# 2020 Corvette: GM TechLink: Front Fender and Fascia Realignment

June 16, 2020  
GM TechLink

**Fig. 11**

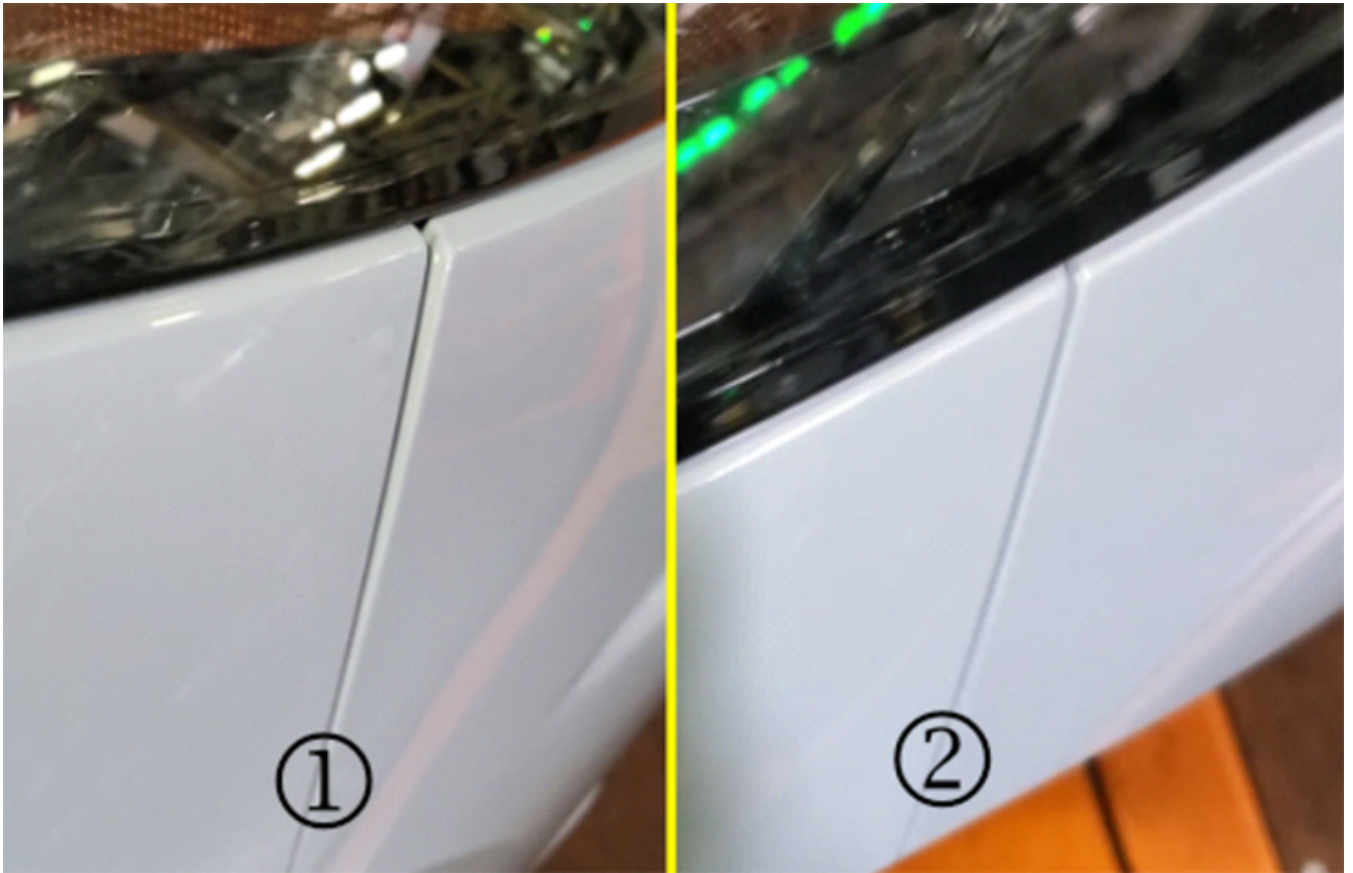
The fender and fascia joint fit should be realigned. (Fig. 11, #1) The realignment will reposition the fender and fascia downward and inboard so that the fascia is flush with the fender. After

realignment, the paint chip will no longer be visible. (Fig. 11, #2)

Follow the realignment procedure in Bulletin #20-NA-124. The front tire and wheel assembly, front wheelhouse liner and front wheel opening molding must be removed on the affected side of the vehicle.

Fig. 12

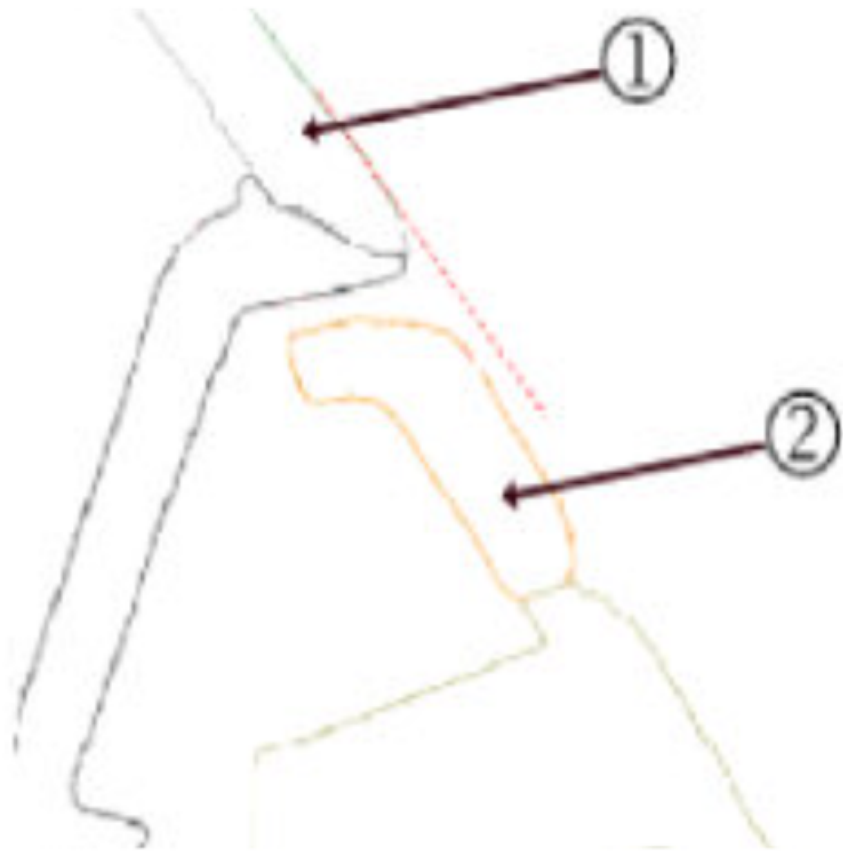
After adjusting the fender inboard, the headlamp lens (Fig. 12, #1) will be proud of the fender (Fig. 12, #2) and the fascia tip will install below the headlamp lens. (Fig. 13)
